CITY OF LA VISTA
MAYOR AND CITY COUNCIL REPORT
MAY 16, 2017 AGENDA

Subject:	Type:	Submitted By:
REZONING AND PUD SITE PLAN APPROVAL — LOT 2, HARRISON HILLS (SW OF 118 TH STREET & HARRISON STREET)	RESOLUTION ◆ ORDINANCE (2) RECEIVE/FILE	ANN BIRCH COMMUNITY DEVELOPMENT DIRECTOR

RECOMMENDATION REPORT

CASE NUMBER: PPUD-17-0002

SCHEMMER COMMENTS 3/29/17

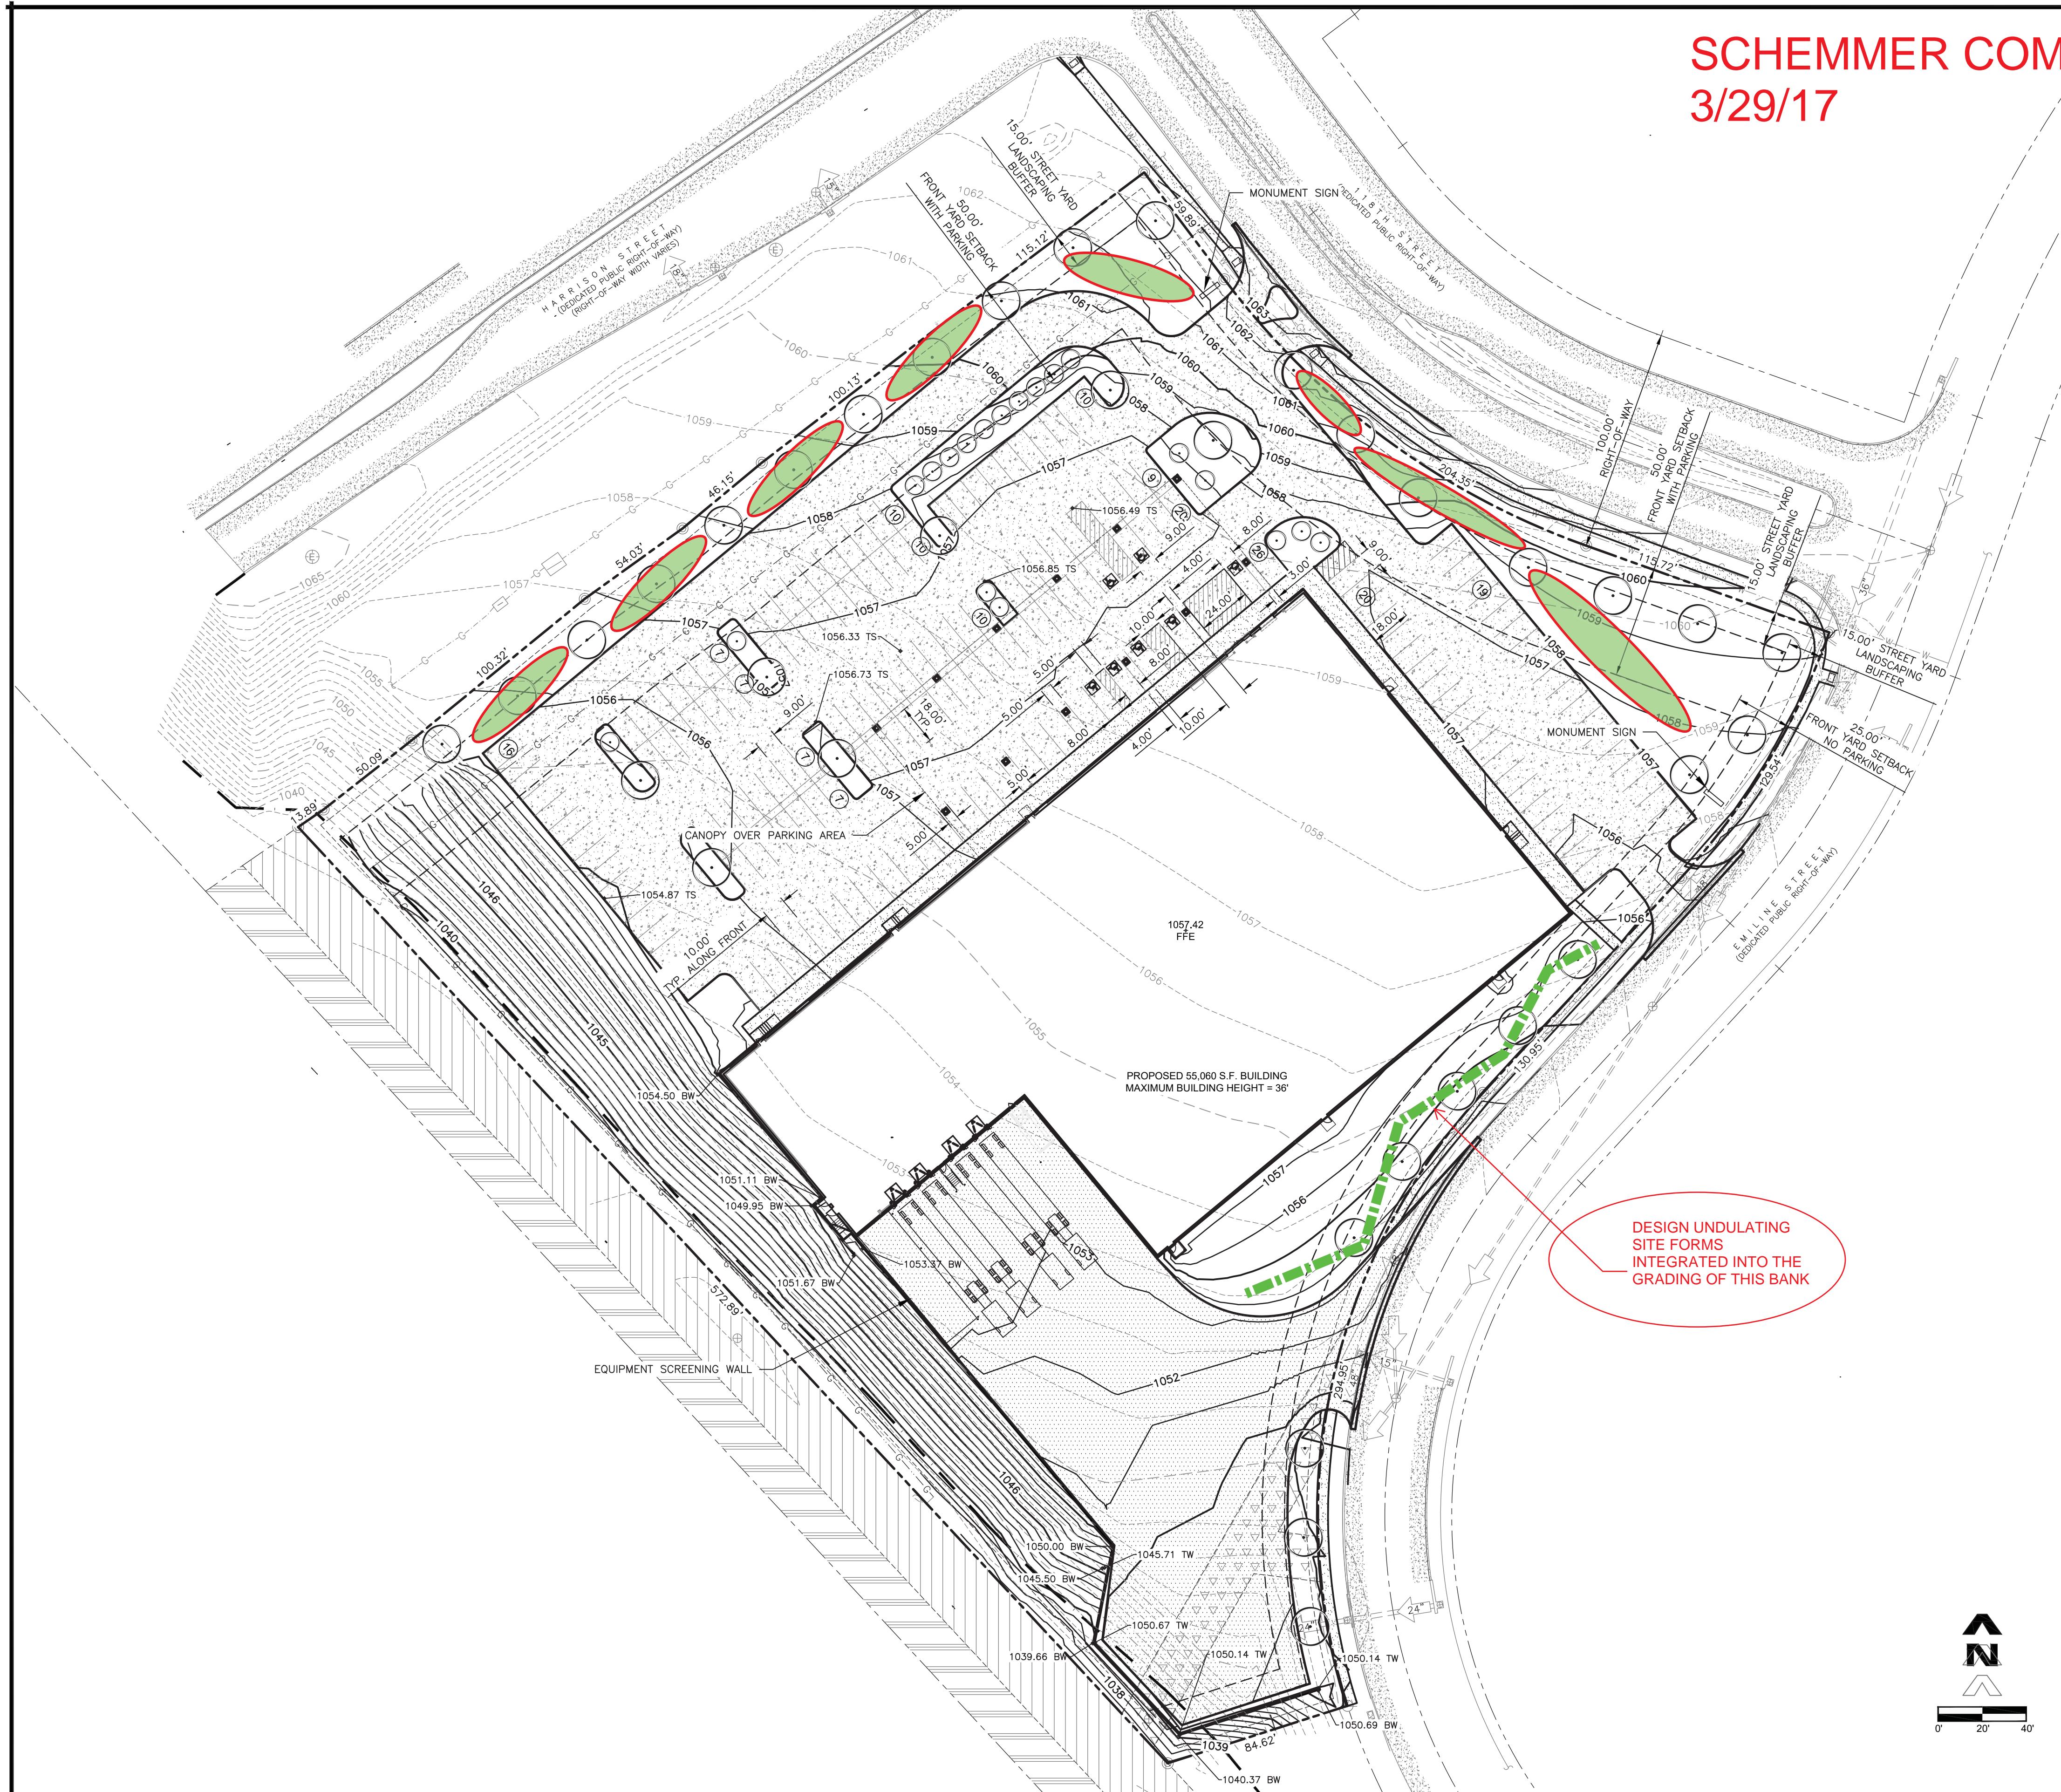
I've received the following comments regarding the PUD Landscaping Plan for the proposed Restaurant Depot from the City's Design Review Architect. Note that these comments do not include comments from City staff regarding the second submittal received last week. Please wait for the second round of comments from City staff before resubmitting.

Attached are some graphic comments to go along with the list below.

- 1) All proposed plant species and the required variety are consistent with the guidelines.
- 2) No natural, undulating site forms are indicated. My PDF sketch notes show some possible locations around the perimeter of the property.
- 3) The dock area should be better screened by coniferous trees to limit street views in summer and winter.
- 4) I don't see any site service equipment indicated yet (e.g. transformer) but those will need to be screened.

DATE
JOB NO. 16356
LANDSCAPING PLAN
SHEET NO.

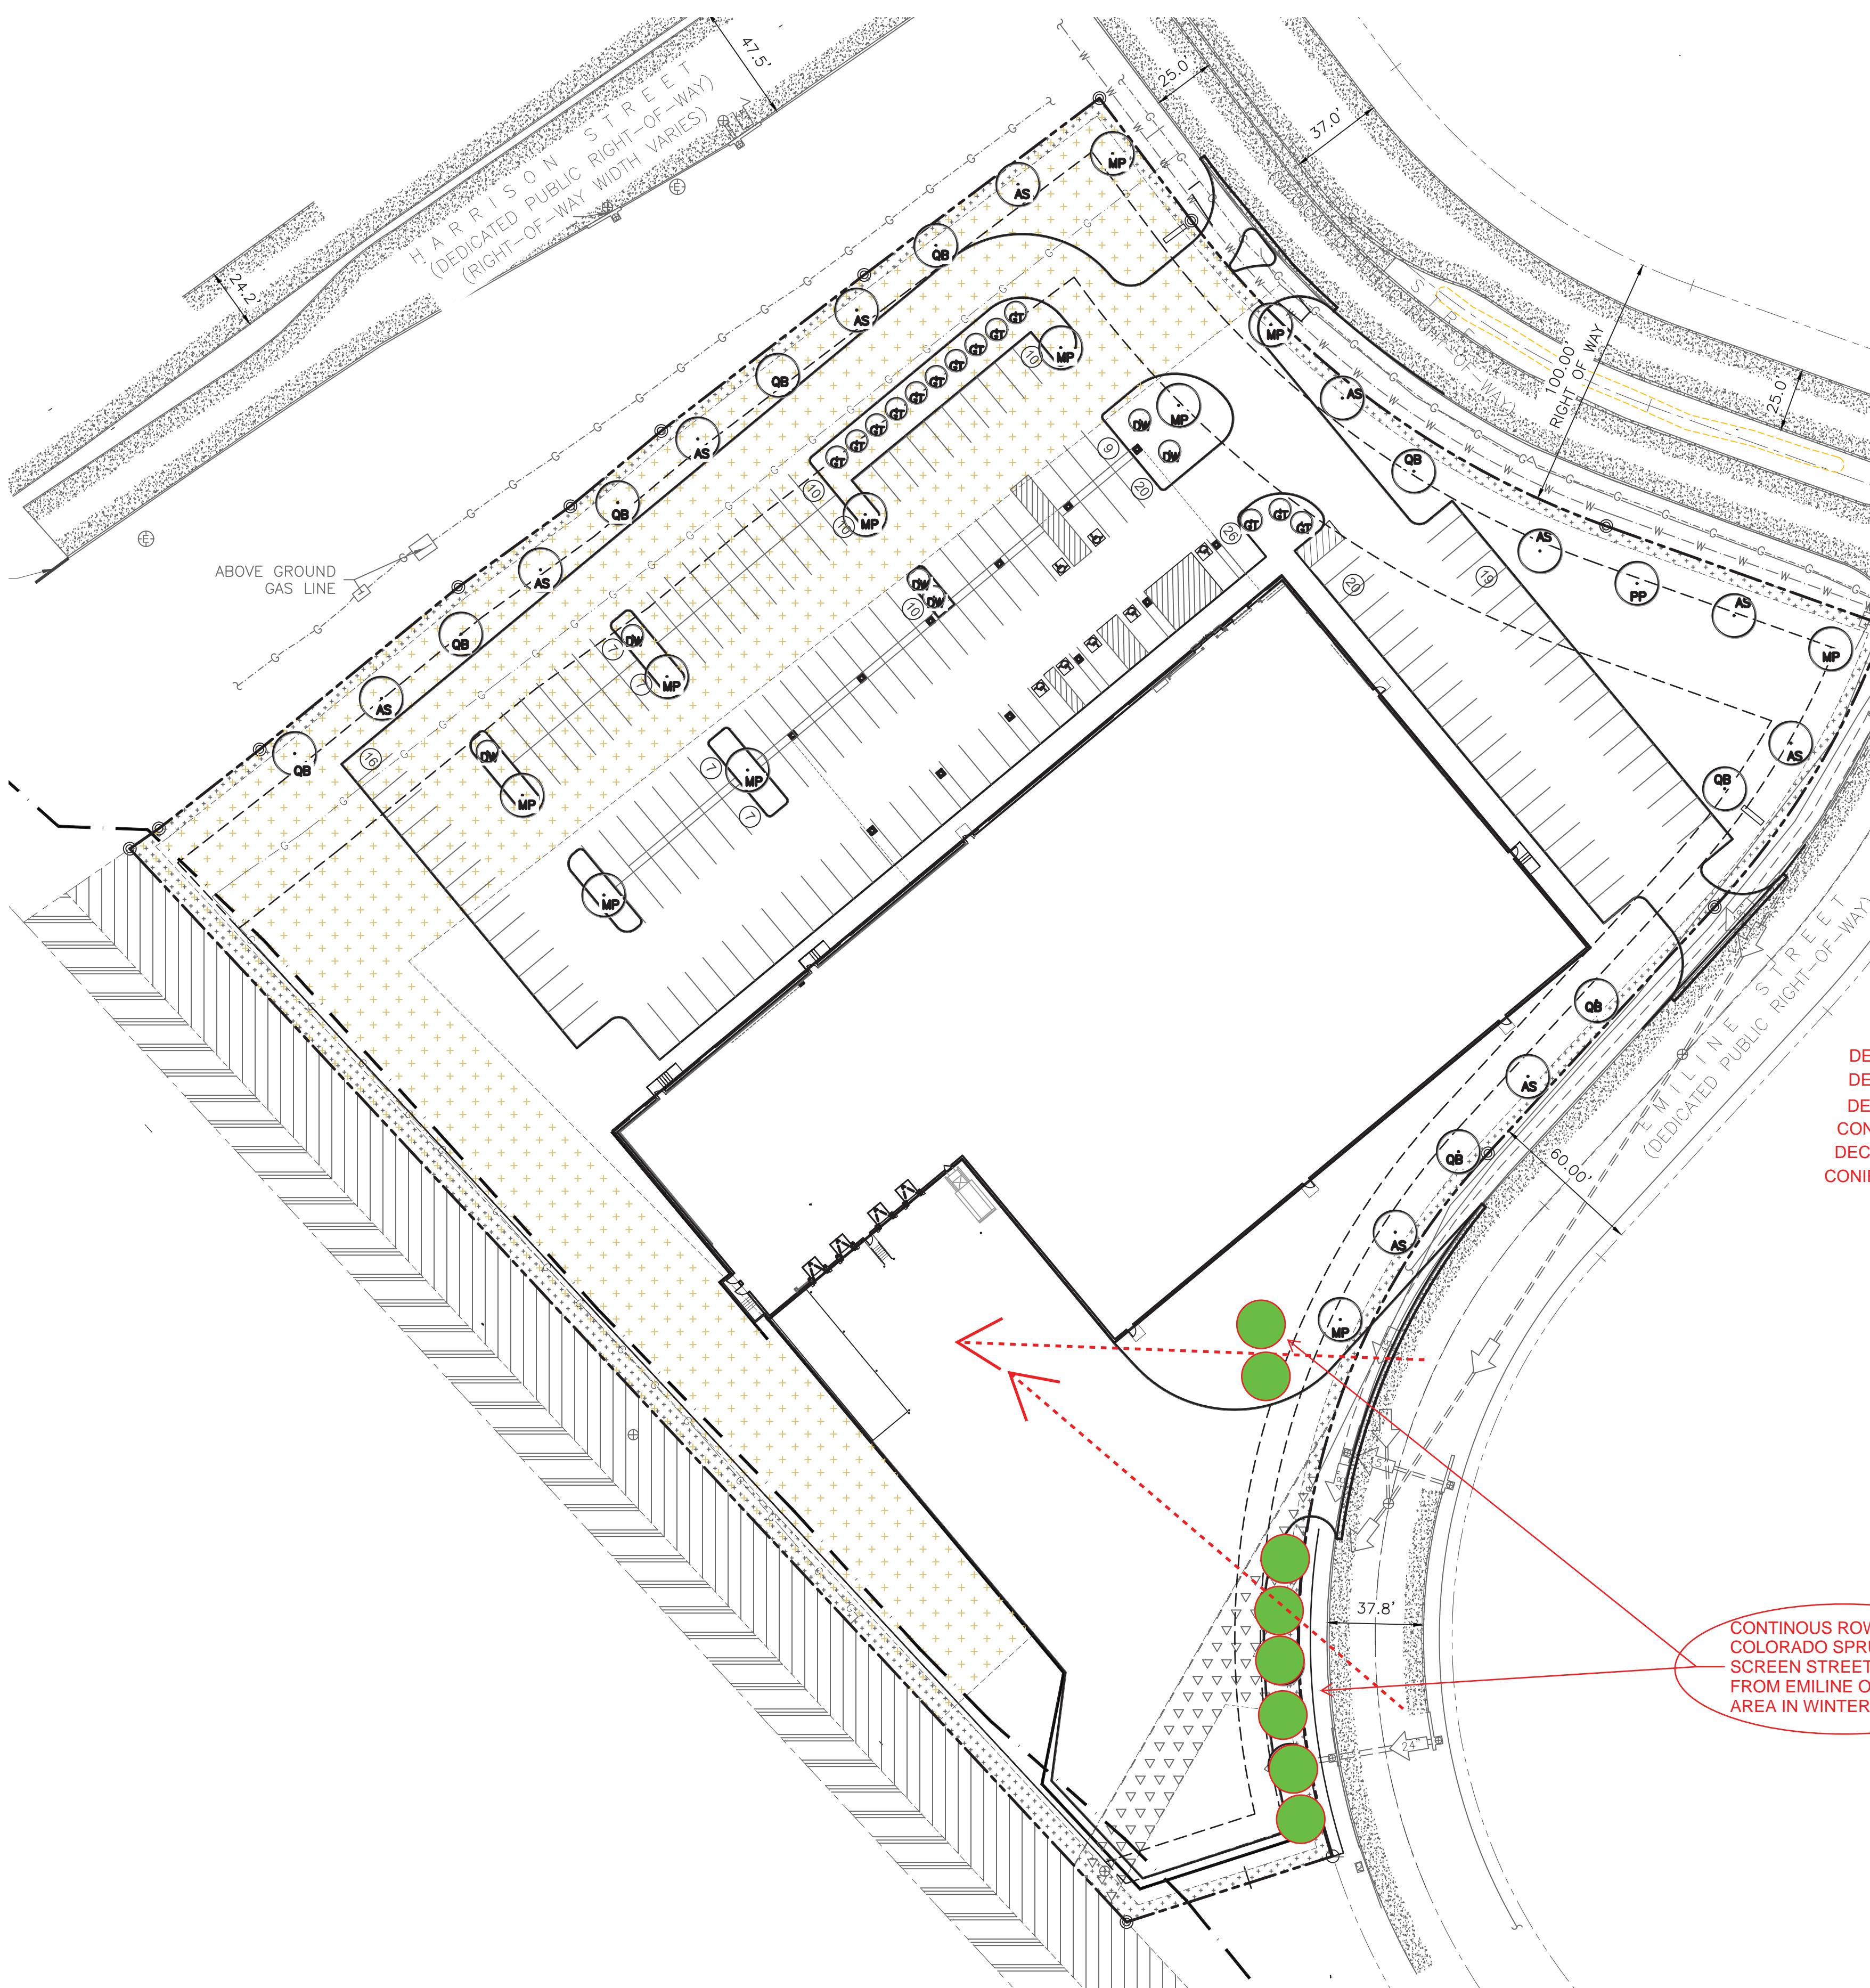
SCHEMMER COMMENTS
3/29/17

GAS LINE EASEMENT AREA
REQUIRING LANDSCAPING
APPROVAL
